Re: The Detroit Edison Company  
AEC Docket No. 50-341

ANSWERS TO U. S. ATOMIC ENERGY  
COMMISSION'S LETTER OF APRIL 20, 1972  
ON QUARRY OPERATIONS

Enrico Fermi Unit 2

Docket 50-341

FIGURE-1

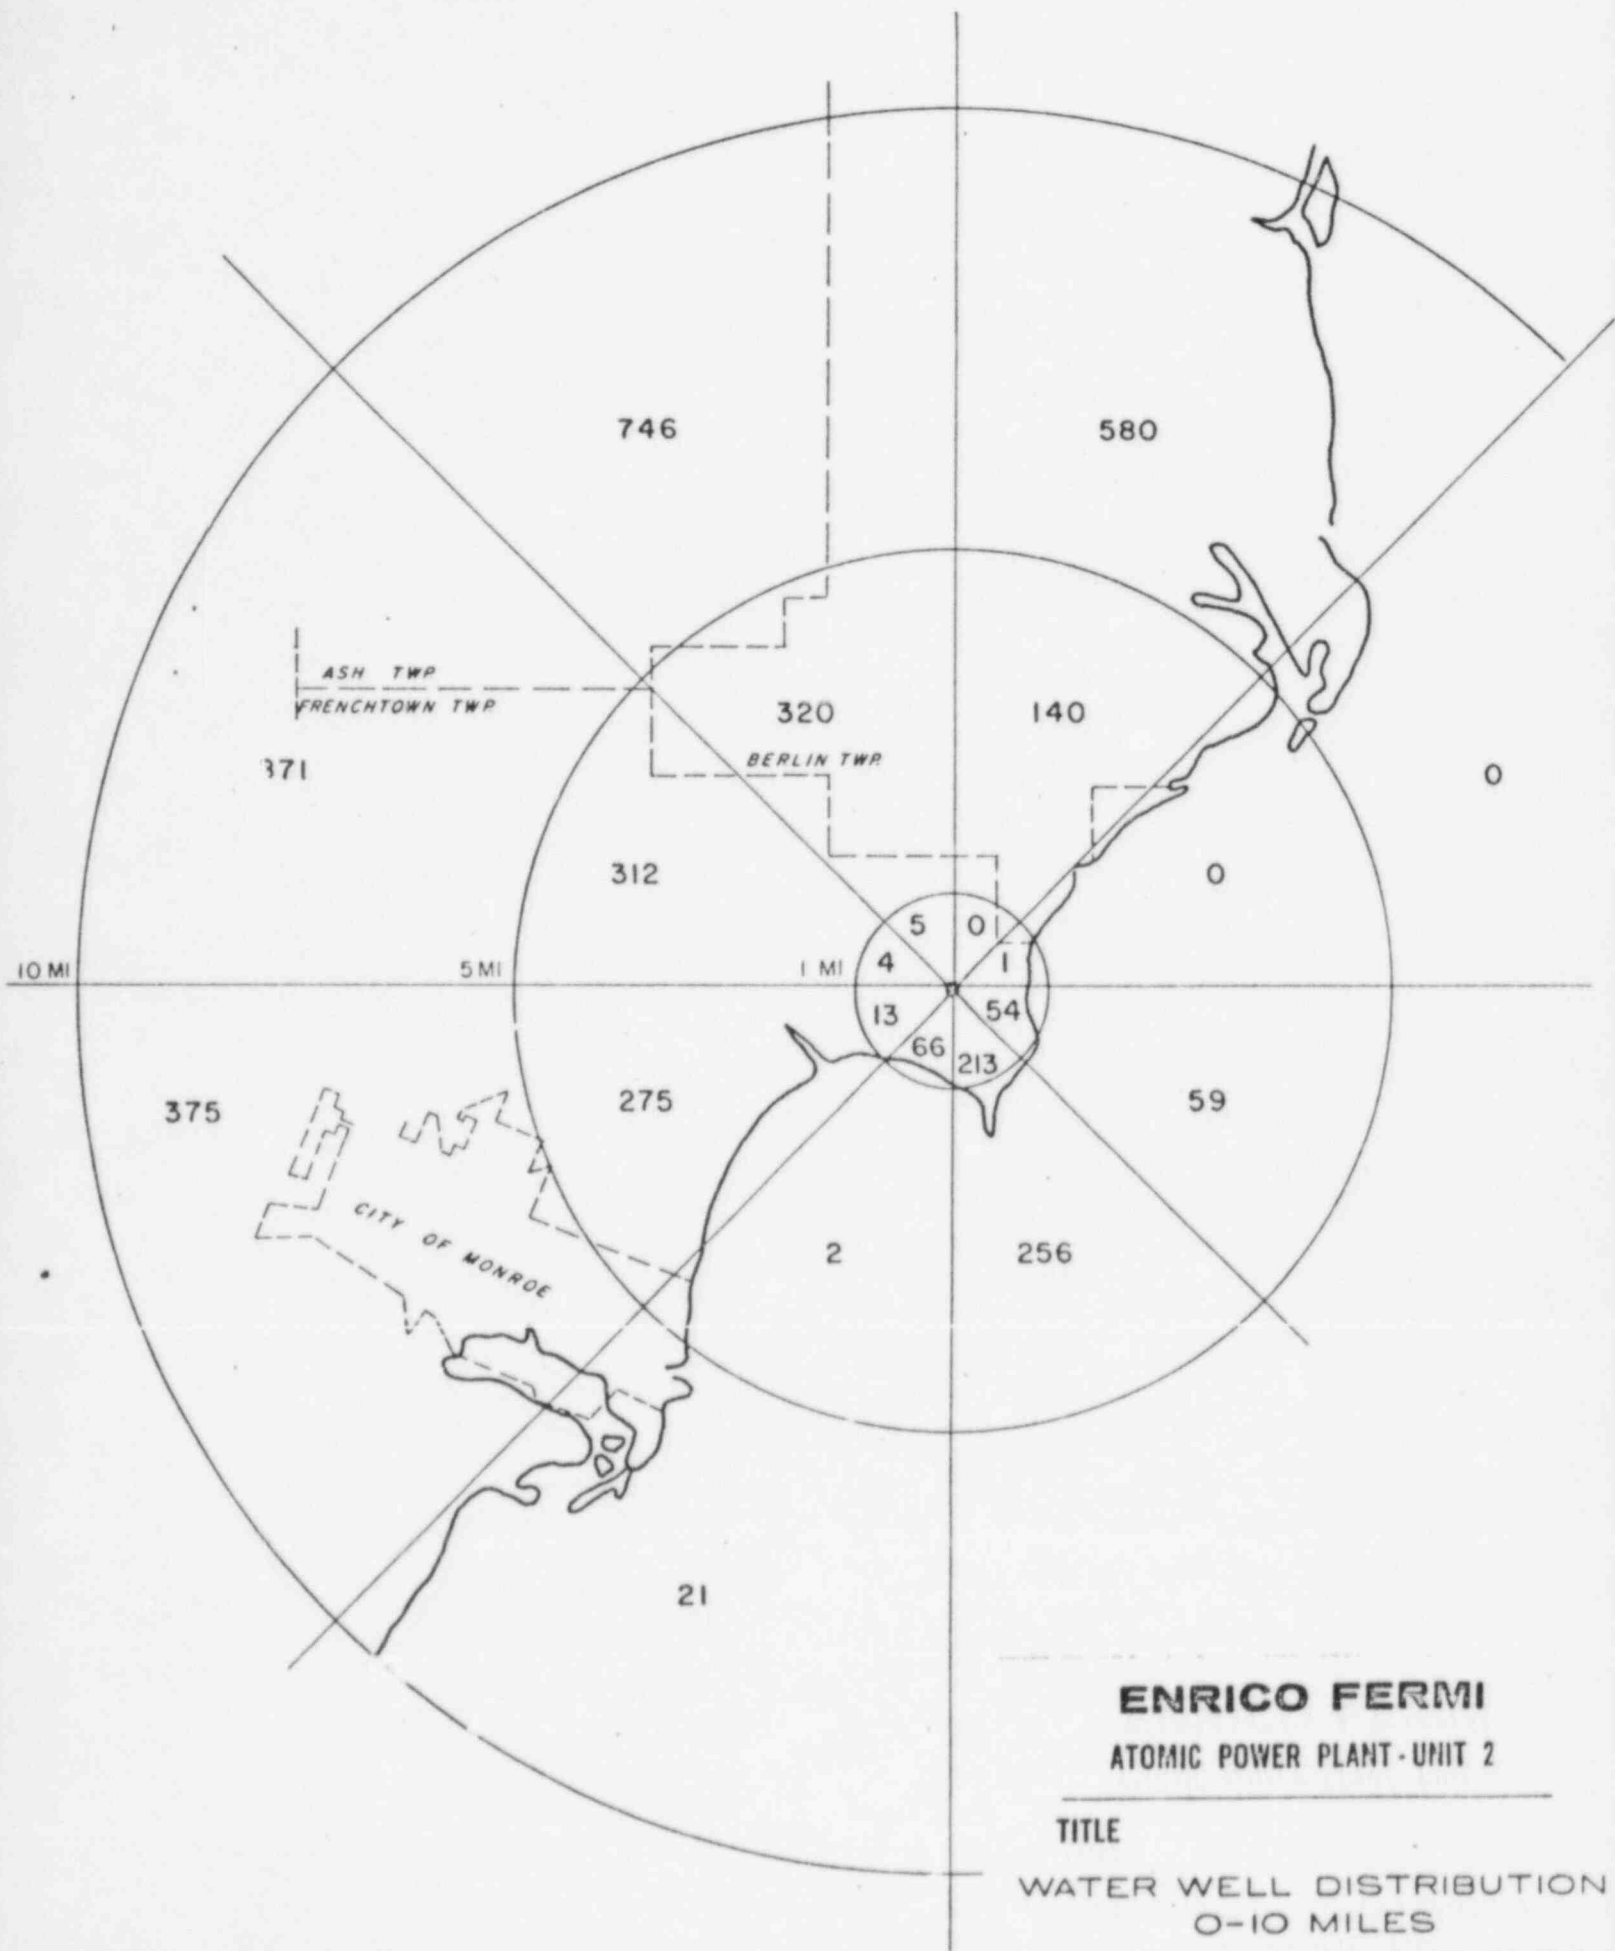
1. Include maps showing the locations and total numbers of wells in each 45° compass sector within 1 mile, 5 mile, and 10 mile radii.

The approximate number of wells now in use and their distribution within 10 miles of the quarry are shown on Figure 1. All wells are small-capacity type for individual household water systems. Municipal and industrial water supplies use surface water sources. The aquifer that supplies water to wells is described in the PSAR, Section 2.4.3.

FIGURE - 2

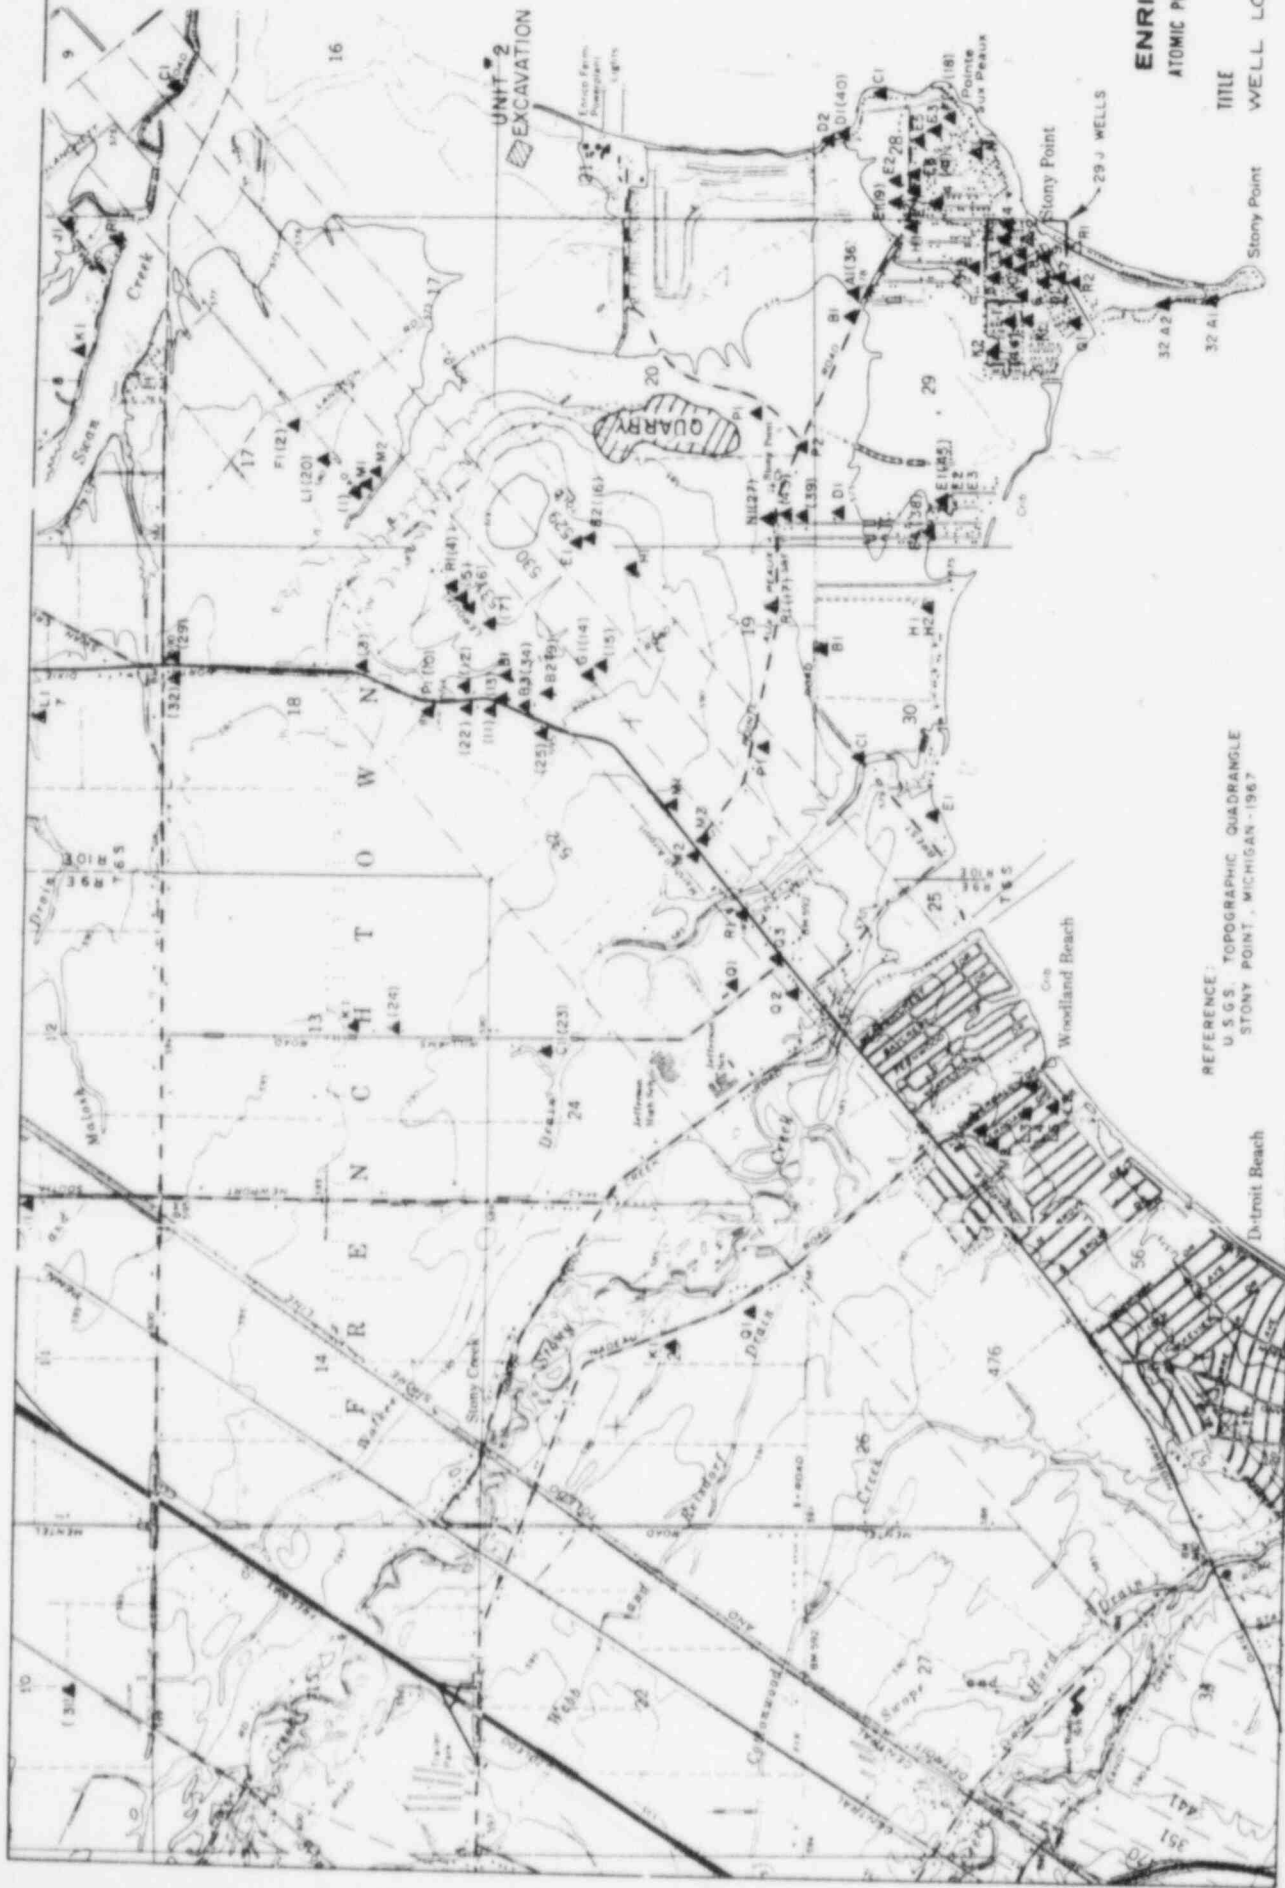
For all wells for which data are available provide

- a. locations, depths of wells and water levels (referenced to a common datum if possible) and
- b. dates of measurements.

All of the wells within the immediate vicinity of the site are shown on Figure 2. These wells are identified and located by the last 2 digits of the above described well numbering system and listed in Table 1 under the heading of "Map Reference Number". Wells shown with an additional number in parentheses are referred to also in our response to Question A-3.

Figure 3. Location of complaints about well water supply.

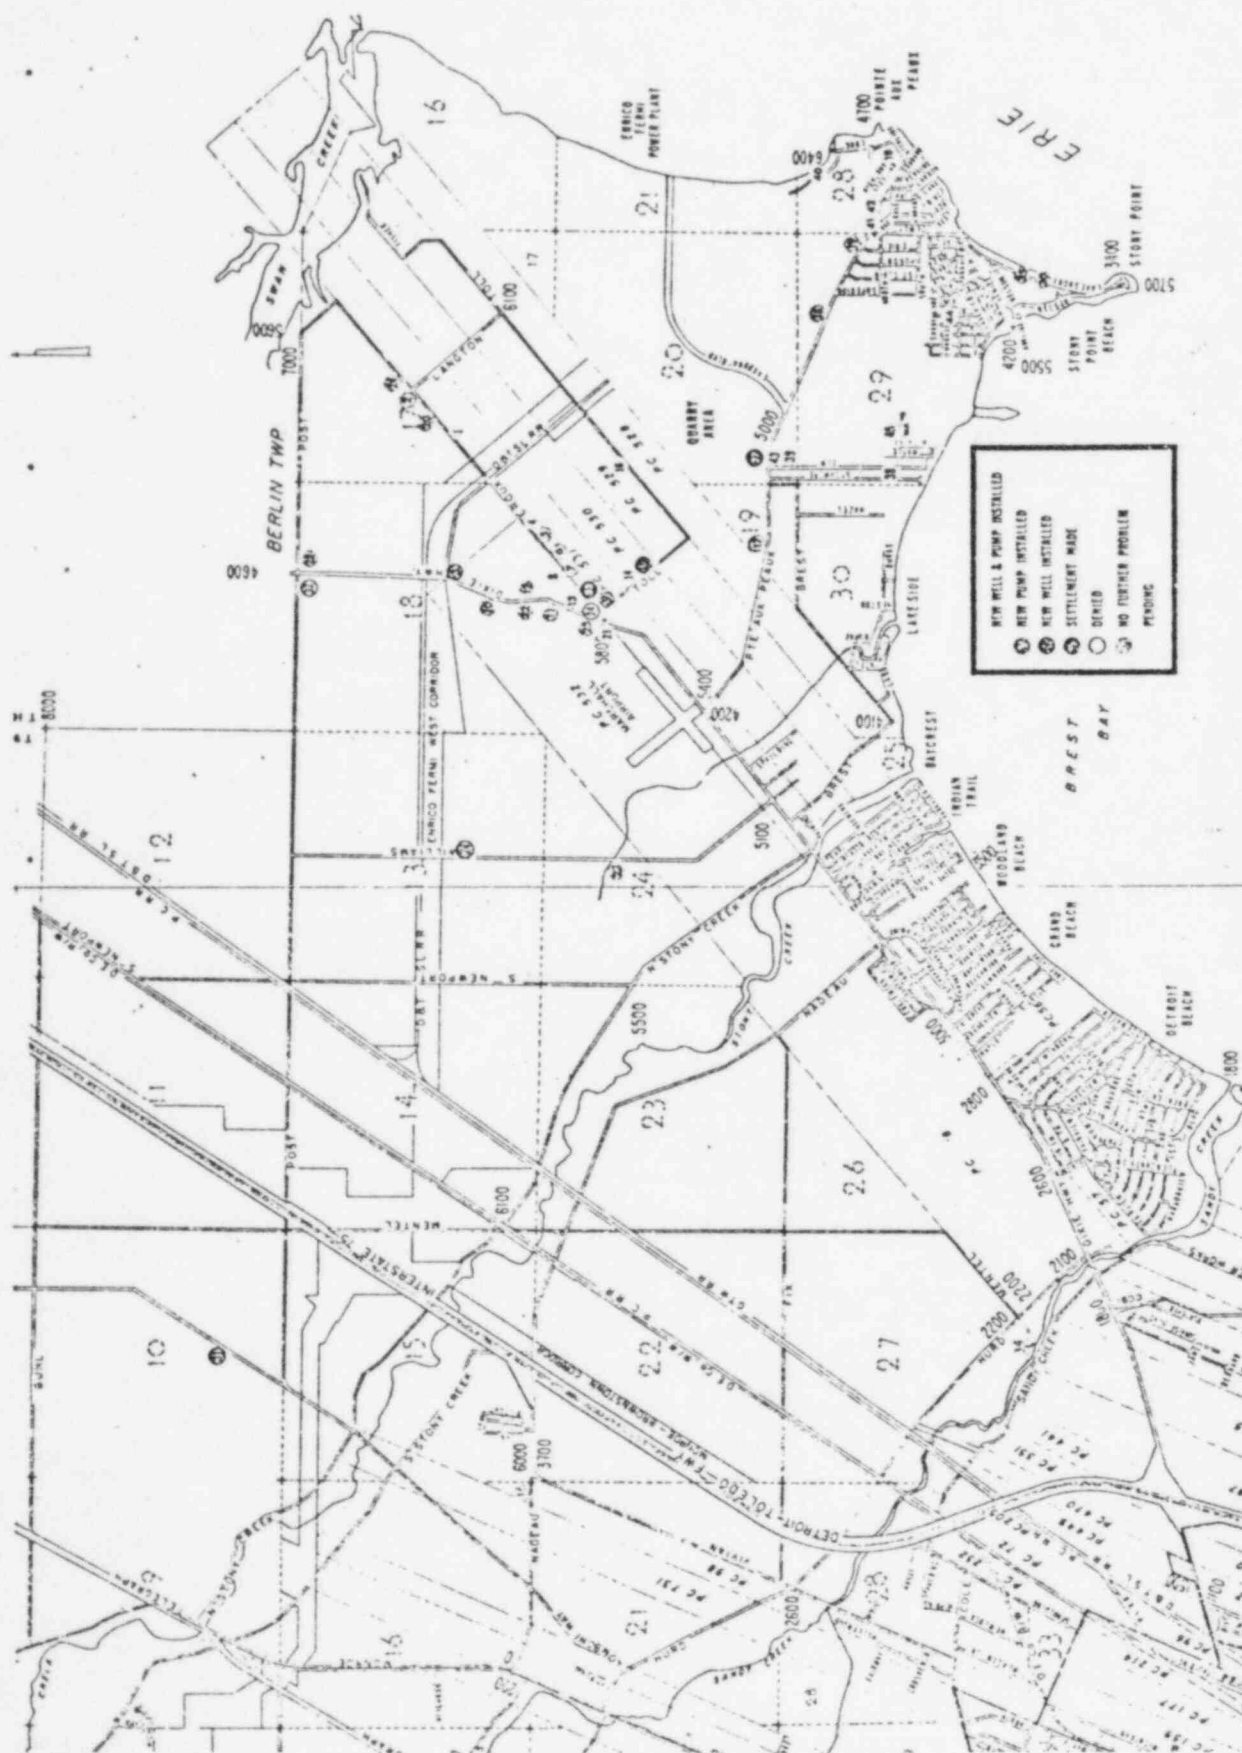
Detail information on wells concerning which complaints have been received including any follow-up actions thereon taken or planned.

An explanation of each classification follows on Table 2, along with a reference map (Figure 3) showing the residence location in proximity to the quarry.

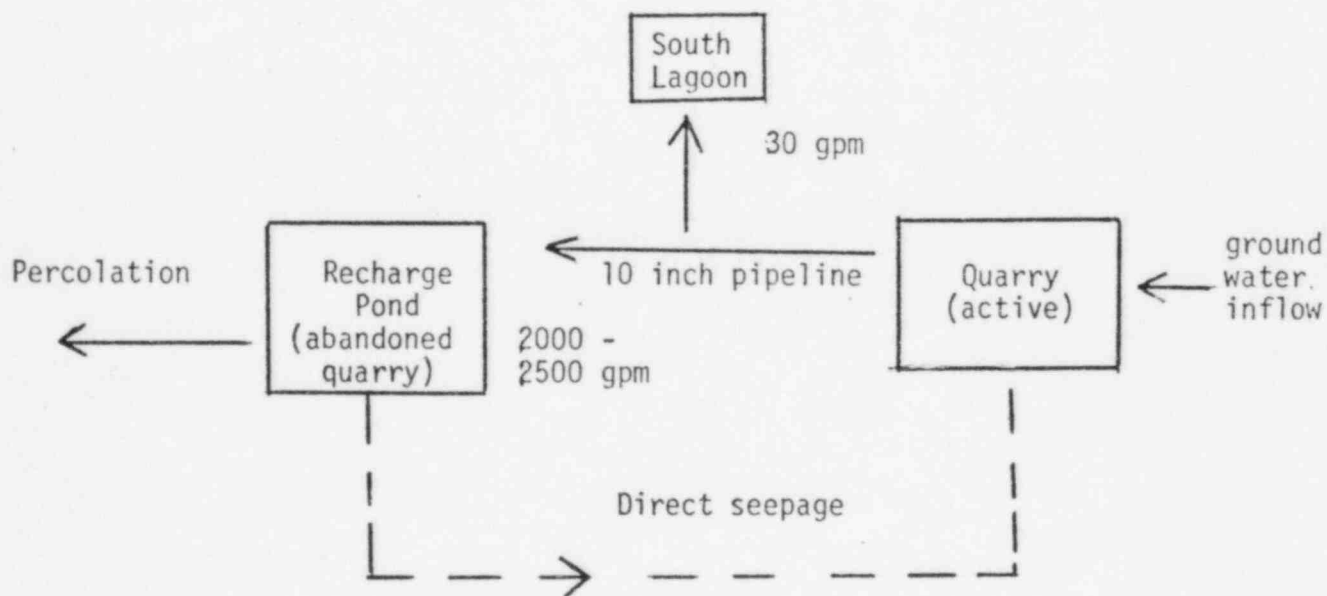
Provide previous, current and anticipated future pump sizes, flow rates and durations of flow in quarrying and in dewatering construction sites, including details on discharge locations.

The pumping system used is illustrated by the following diagram.

**FIGURE-4**

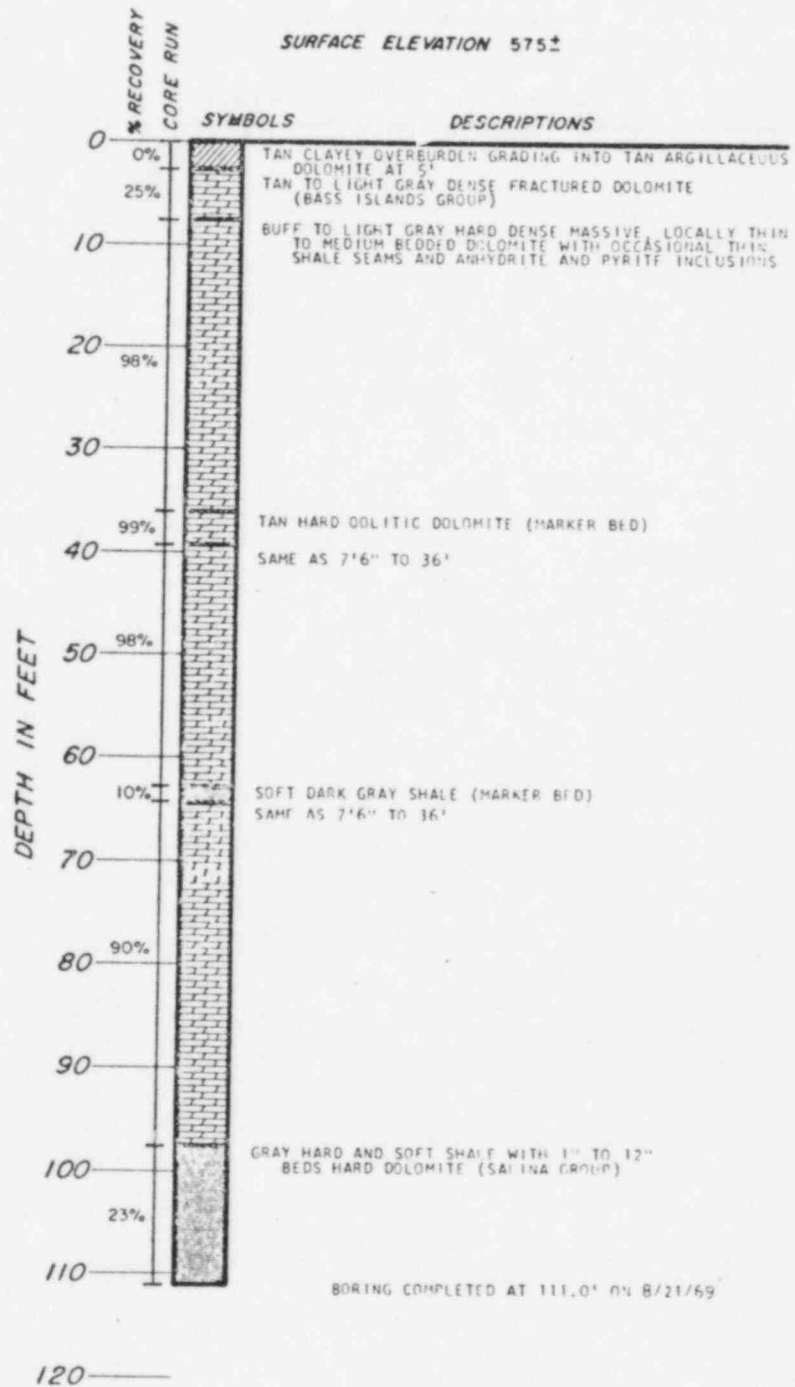
Provide information, such as data from borings near the quarry, to indicate the types of ground water strata that might be encountered in future quarrying. What further lateral and vertical excavations of the quarry is planned for the completion of Fermi 2 or for future construction.

The local aquifer is described in PSAR Section 2.4.3. A log of a boring at the site of the quarry (Figure 4) shows that fractured dolomite extends as a continuous hydrologic unit to about 100 feet depth. The rock cuts exposed in the quarry have not encountered any deviation from the rock conditions indicated on the log. Borings data (see PSAR) indicate a general uniformity of rock conditions throughout the site area.
